UNITED STATES PATENT AND TRADEMARK OFFICE

APPLICATION NO.	FILING DATE	FIRST NAMED INVENTOR	ATTORNEY DOCKET NO.	CONFIRMATION NO.
09/780,480	02/12/2001	Akira Senoo	Q62848	8117

Office Action Summary

DETAILED ACTION

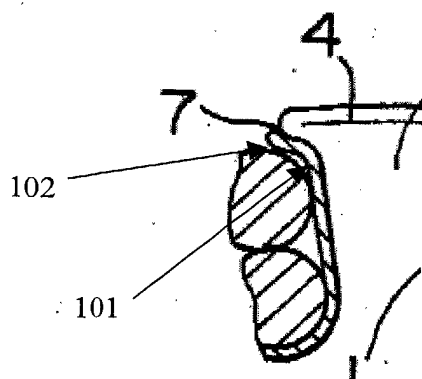
Honshima et al. clearly teaches the construction of an armature for an electric rotary machine, the armature comprising:

an armature core (2) provided with a plurality of slots (1) extending in an axial direction and disposed alongside each other in a circumferential direction;

an armature winding (3) inserted in the slots so as to be mounted on the armature core; and

an insulator (6) mounted in each of the slots wherein:

the insulator is disposed between an inner face of each slot and the armature winding (Figures 1, 2A, 2D, 4, 5A and 5B); and

first creases (101, added by the examiner) are formed on side portions of each insulator so as to extend in a lengthwise direction of the slot at a slot-opening end of the side portions, the first creases being formed by first bent parts for angling the slot-opening ends of the side portions so as to be apart from each other.¹

7. With regards to claim 11, Honshima et al. disclose second creases (102, added by the examiner) are formed on the side portions of each insulator so as to extend in a lengthwise

direction of the slot at a location closer to the slot-opening end than the first creases, the second creases being formed by second bent parts for angling the slot-opening ends of the side portions toward each other.
